# 802.1Qcc findings

Astrit Ademaj

Sept 2018

## 3 & 4. Latency and Redundancy requirements for talkers

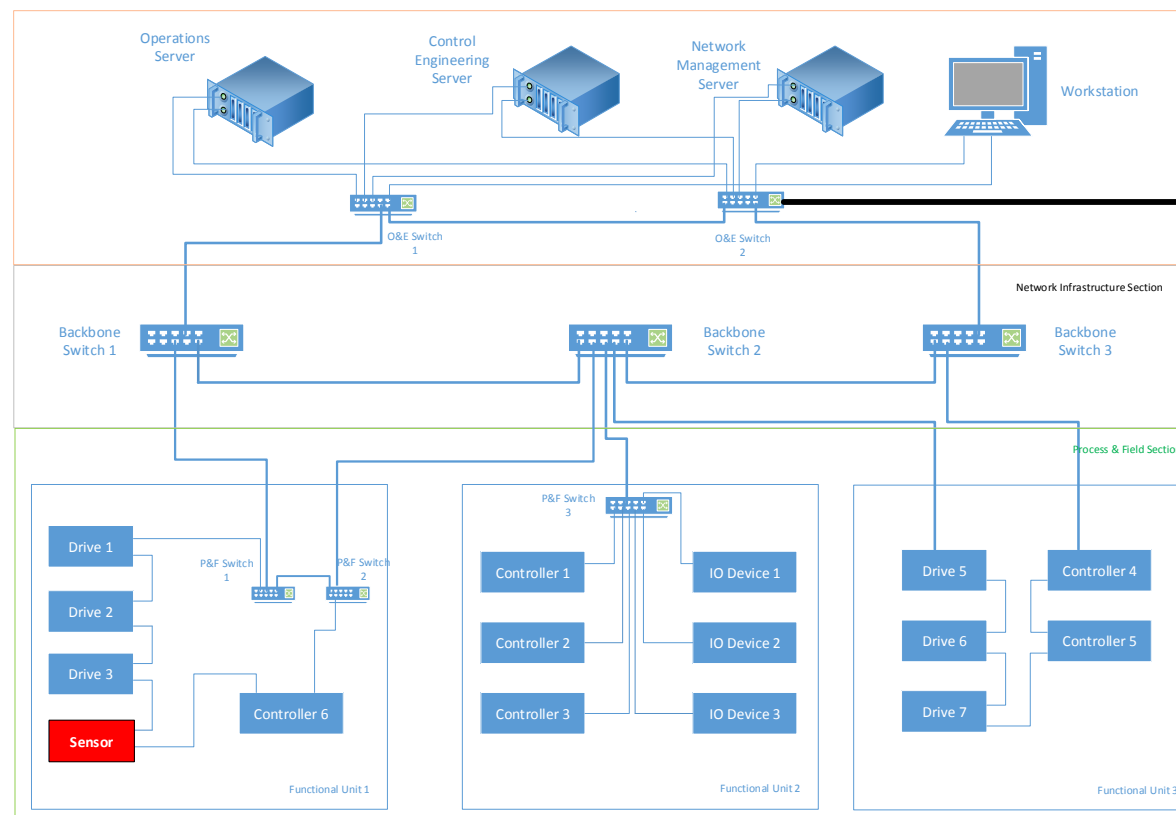
- *Latency* and Number of Seamless Trees at talker(s)
  - Some listeners may have same latency and redundancy requirements some not (e.g., a monitoring HMI device)
  - In some use cases setting the redundancy and latency requirements at the talker may cause conflicts with the listener requests

### Proposal 3:

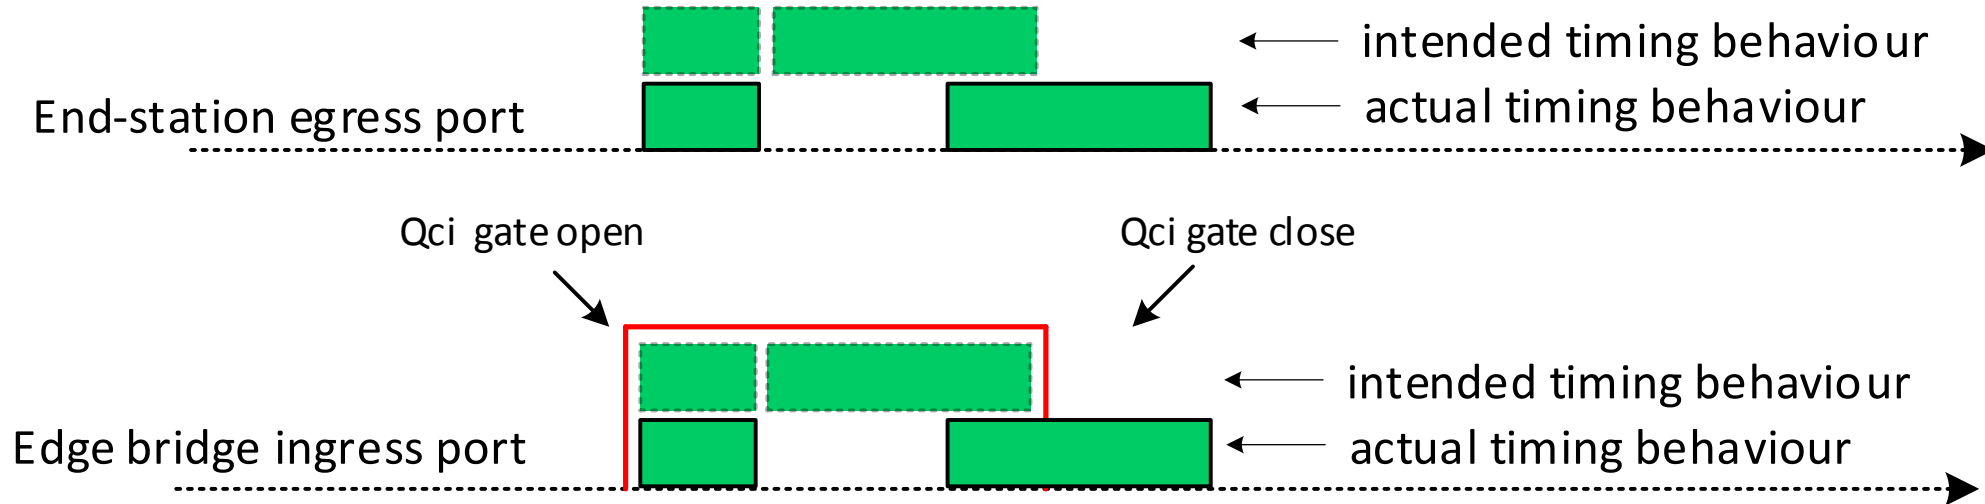
- Either remove the latency requirement at the talker,
- or add informative text to explain the possible implications if used

## 5. Maximum Transmission GAP between two successive frames (2)

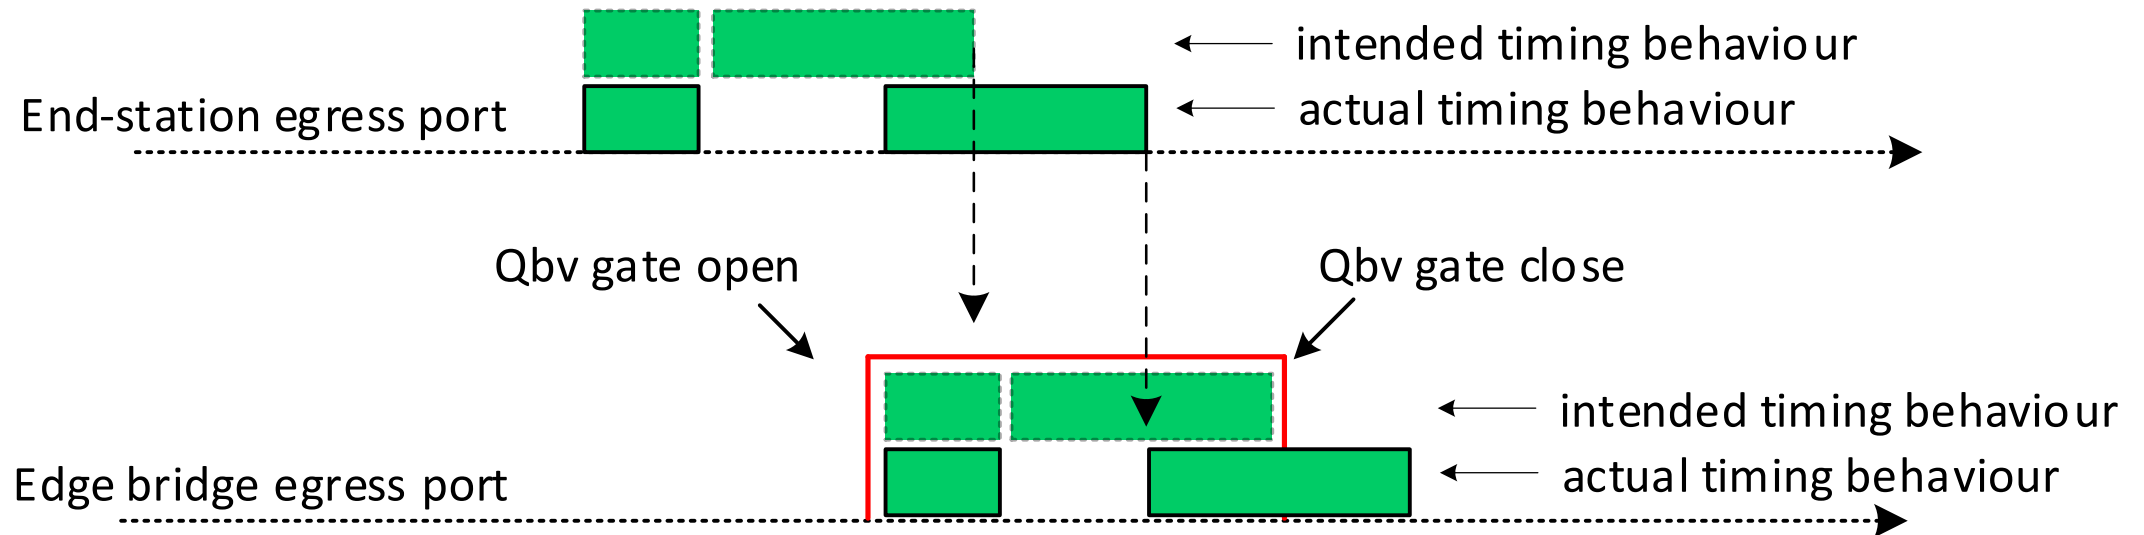
- Without taking that into consideration, the CNC make generate bridge schedules that may lead that a frames from a scheduled stream miss a gating “slot”

- Add a parameter to specify Maximum Transmission GAP between two successive frames as a part of end-station capabilities (constraints) – similar to the jitter parameter.
- If the parameter is not set, Missing info about this parameter – use standard value of IFG
